From: Helgardt Slabbert <helgardt@valumax.co.za>
Sent: Friday, September 11, 2020 2:39 PM
To: Vanessa Stippel
Cc: De Wet Botha
Subject: RE: 21637 | Notification of Public Review of EIA Report and WULA Technical Report | Proposed Development of Riverside View Extension 84, City of Johannesburg, Gauteng (GAUT 002/17-18/E2040)

ADDENDUM 1 | RESPONSE TO CITY OF JOHANNESBURG IMPACT ASSESSMENT AND COMPLIANCE MONITORING COMMENTS DATED 12 OCTOBER 2020

ADDENDUM 2 | RESPONSE TO GDARD'S COMMENTS DATED 26 OCTOBER 2020

Figure 8: Google Earth Imagery from May 2015

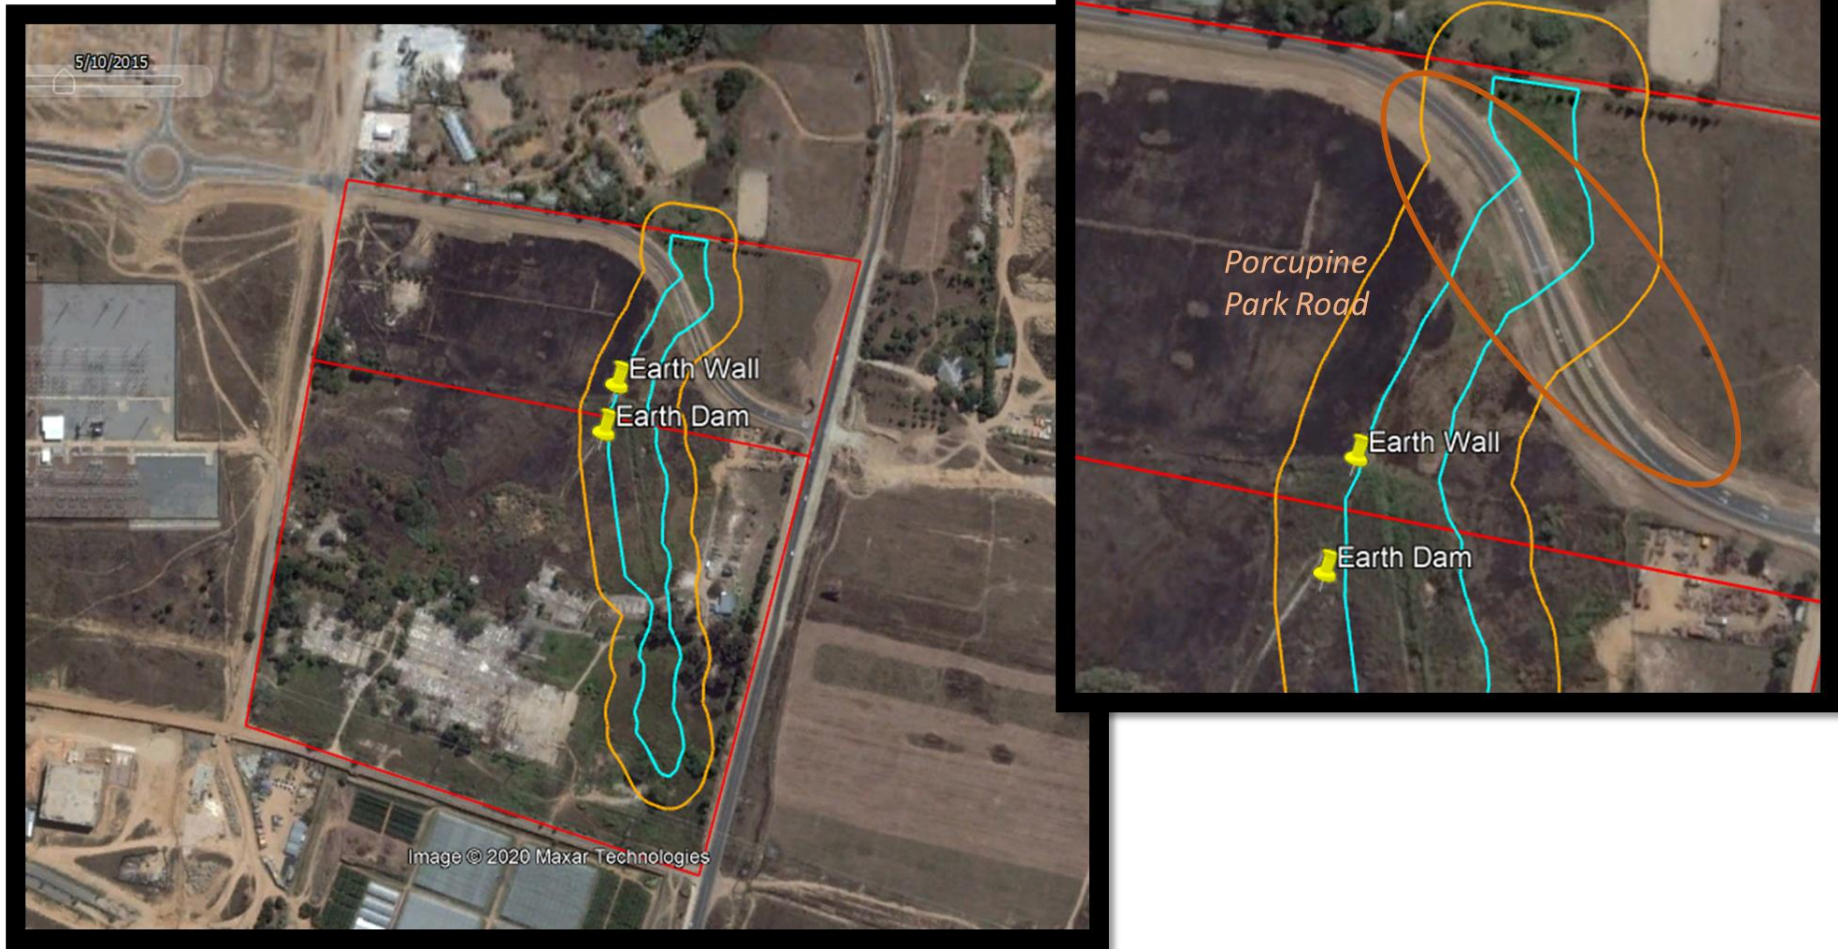
- *Further, the geotechnical report by the engineering geologist confirms the presence of seasonal perched groundwater tables and/or saturated soil profiles, not confined to the riparian zone only. Figure 9-11 indicates extensive areas designated as Zone III which are noted to be wet and marshy. This would be consistent with the National Wetlands Map 5 (Van Deventer et al 2019) and the City's own indicative wetland layers. The historic vegetation maps appear to show these areas in existence. Furthermore, extensive seep wetlands associated with valley bottom wetlands is a common feature of the Halfway House Granites.*

Google Earth imagery has therefore been utilized to provide a summary of the historic use of the site and how this has affected surface water. The aim of this is to provide a timeline and place the findings of the Geotechnical Studies into context as well as the findings of the Baseline Biodiversity Baseline and Impact Assessment.

Please refer to **Figure 2, 3 and 4** below.

*“The general slope of the area is to the north with locally gradients towards the east and west due to a shallow stream channel running from south to north through the eastern part of the holding. **The drainage feature has been modified due to stormwater trenches, runoff from large concrete paved areas and septic tank drainage fields. A stormwater drainage ditch runs through the central part of the holding into an earth dam on the central northern boundary with the golf driving range. The shallow stream and dam areas will be prone to marshy conditions. Locally levelled platforms were created via cut to fill to accommodate the large paved areas and buildings.**”*

*The northern parts of the site have been left fairly undisturbed apart from the **shallow dam in this area**. The school on the western part comprises of classrooms, sports fields and open veldt area to the north. The Lulamisa Eskom Substation is situated directly adjacent to the west of the property.”*

Figure 10: Location of earth dam within degraded grassland

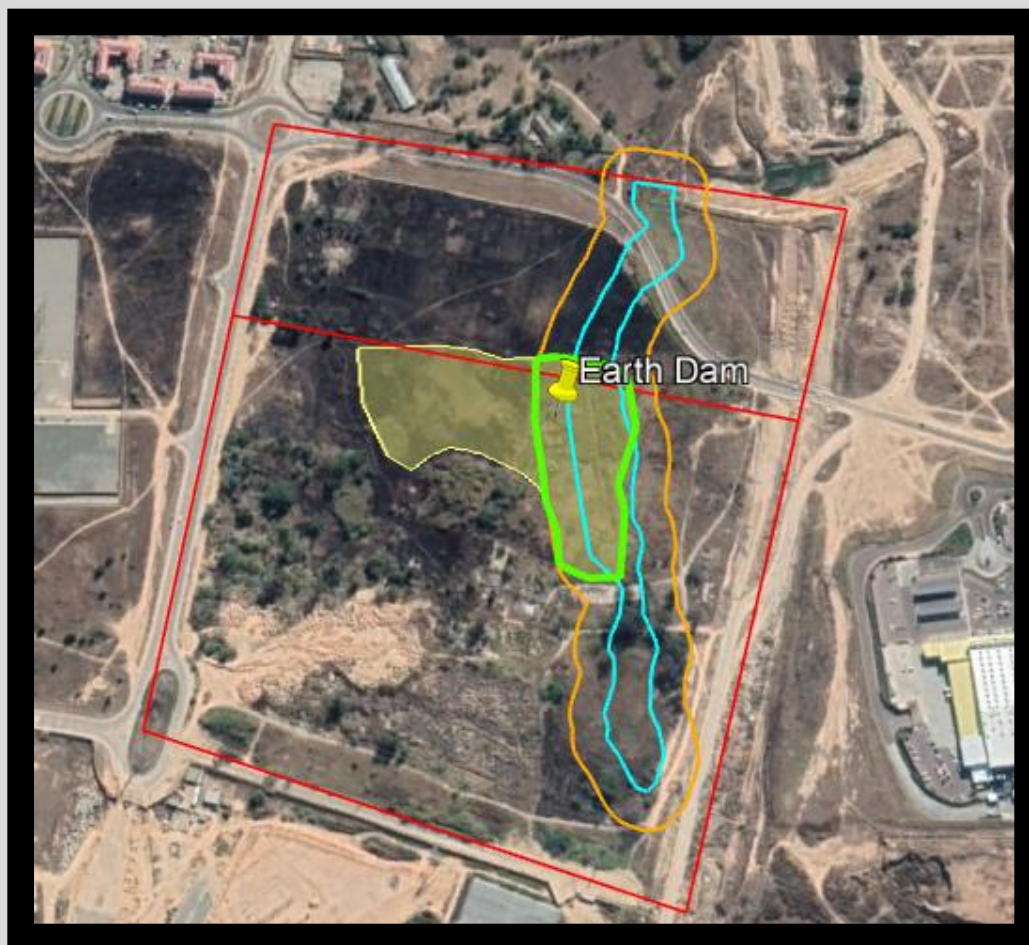
One of the main concerns raised by the Municipality was in regard to the artificial water source that was noted in the Biodiversity Baseline and Impact Assessment (The Biodiversity Company, 2019) and the Wetland Assessment (Prism EMS). In particular, they noted that the above-mentioned studies did not provide sufficient information on why this was an artificial source. An excerpt of the comments regarding this are provided below:

Furthermore, it should be noted that the earth dam occurs within the degraded grassland area which was identified by the Biodiversity Baseline and Impact Assessment and shows its artificial nature.

Figure 12: Typical cross section

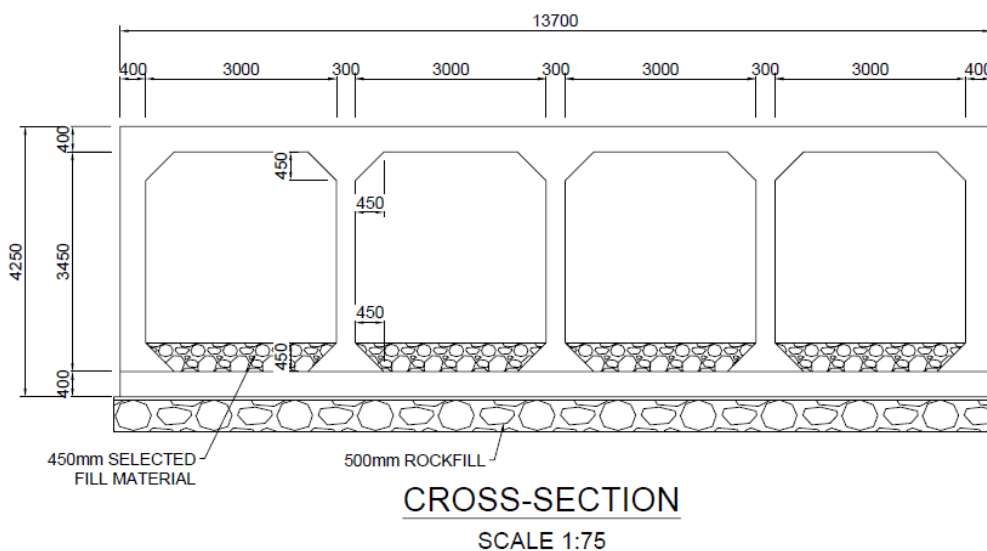
- *“The proposed watercourse crossing must be undertaken in such a manner that it does not impact on the hydrological process; thus, a hydrological study must be undertaken to assess the impact of the proposed crossing. A span bridge is recommended.”*

Whilst conceptually a span bridge appears to reduce the impact, this is more in relation to riparian areas. From discussions with the Wetland Specialist and Engineers, it should be noted that due to the nature of the wetland and surface flows, the pillars would need to be sunk to a level were a greater impact would be experienced. Instead, the engineers (in consultation with the specialist) have recommended a culvert which rests on a “raft” of stone which will allow for continued subsurface flow and avoid intersection with the lateral interflow. This reduces the impact to the wetland and wetland habitat. **A span bridge is therefore not recommended from a wetland perspective.**

Figure 13: Stormwater Management System showing Multiple Releases

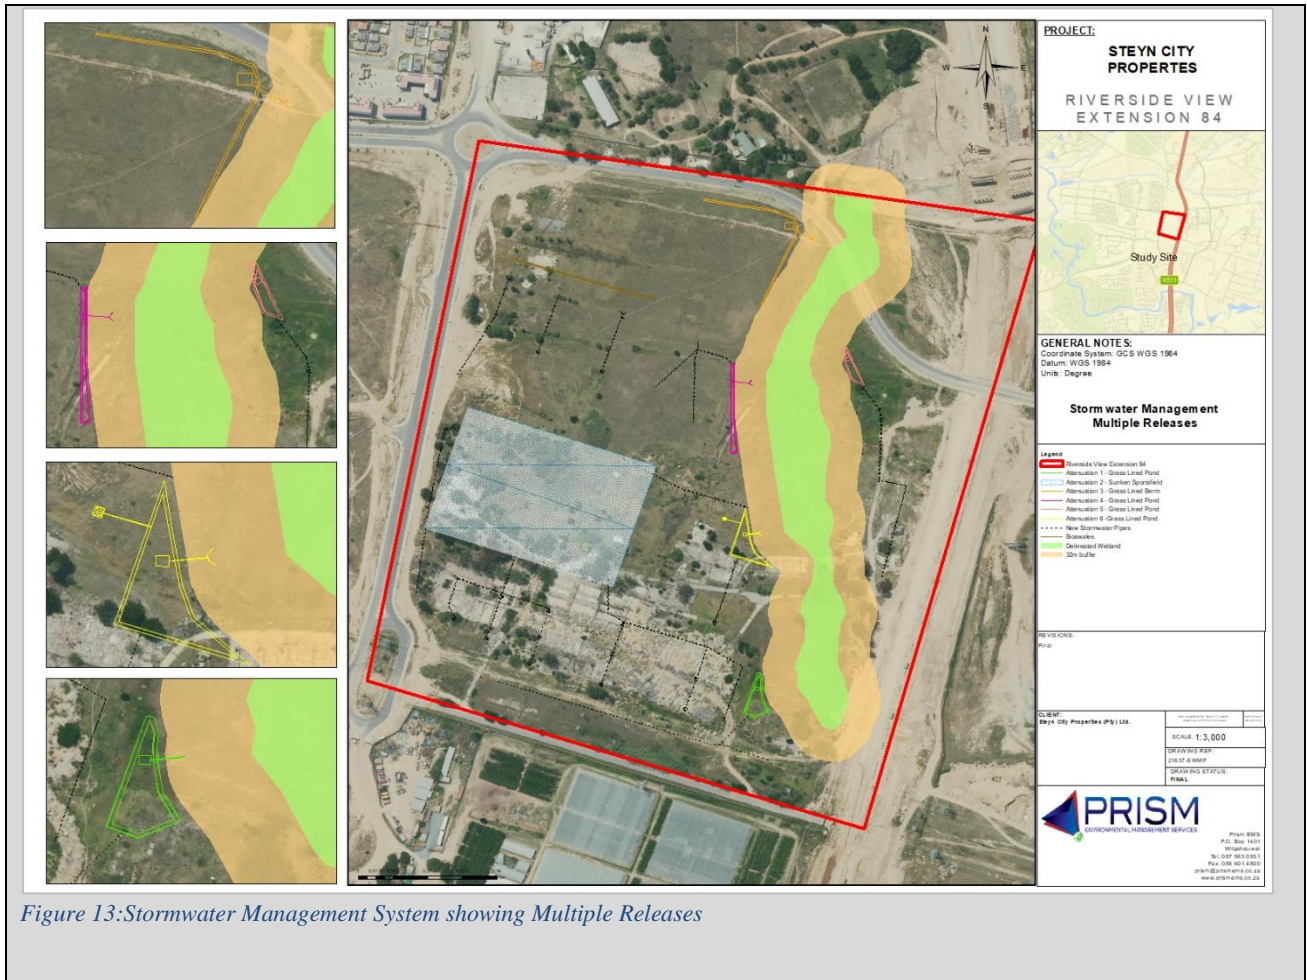
- *The design of storm water management systems should be based on the Stormwater by-law, 2010, Sustainable Urban Drainage Systems (SUDS), and Water Sensitive Urban Design approaches (WSUDS) which enhance natural drainage through permeable surfacing and integrates landscaping with storm water in line with best practice storm water management. Although the report mentions some principles which are part of the Stormwater by-law, the attenuation ponds show single points on discharge into the buffer or the 1:100 year floodline. The stormwater must be discharged in manner that maximises wetland and open space functionality and limits potential erosion. Stormwater must be managed to the satisfaction of JRA and the Environment and Infrastructure Services Department.*

A stormwater management plan has been compiled by a professional engineer and provides for discharge overland within the wetland buffer. The plan utilized SUDS and all run-off from the site will be routed to the attenuation ponds of each respective catchment. Each catchment area drains into an attenuation pond whereby the run-off from the area is throttled to release into the wetland and buffer zone at the 1:5 year pre-developed flow. Energy dissipating structures will be constructed at each outlet to limit any erosion and encourage sheet flow into the wetland area.

Figure 13 provides an overview of this plan and highlights that there are 6 separate releases along the wetland buffer at separate locations. It is not necessary to include multiple releases from each attenuation due to the fact that the site has been separated into small catchments and each catchment has its own release. It therefore has the same effect as having multiple releases from the same attenuation.

Figure 1: Proposed Wetland Crossing

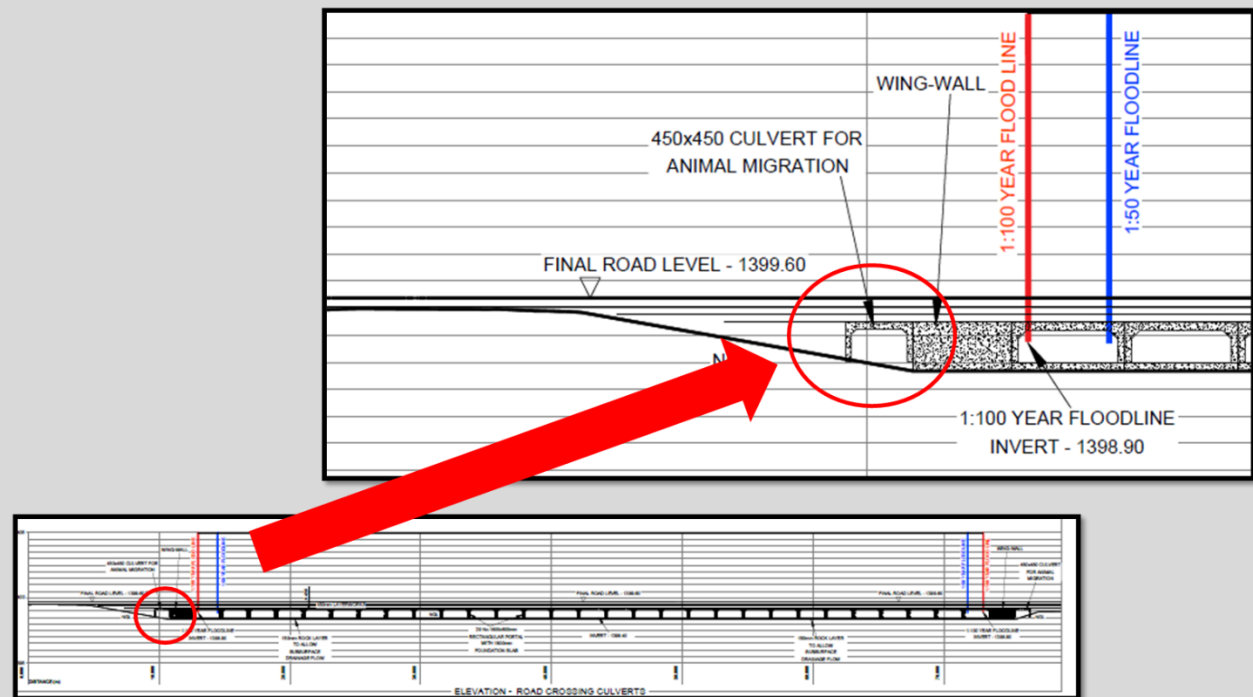
- *The activity 19 of listing notice was applied to cater for the bridge to access Erf 2 the plan bridge must be environmentally friendly so that the animals within the wetland will be able to migrate*

As per Page 12 of the Stormwater Management Plan (Tekciv, 2020) that was included in the Appendix 14.6.9, "A road-bridge will be constructed which allows for the 1:100 year flow of 8.7 m³/s to pass under the road. The bridge is to be constructed of pre-cast portal culverts and will extend the full width of the flood line. To cater for animal crossings, smaller culverts will be placed above the flood line to allow for migration.

Please refer to **Figure 1** below which indicates the proposed wetland crossing including the smaller culverts which cater for animal crossings outside the floodline.
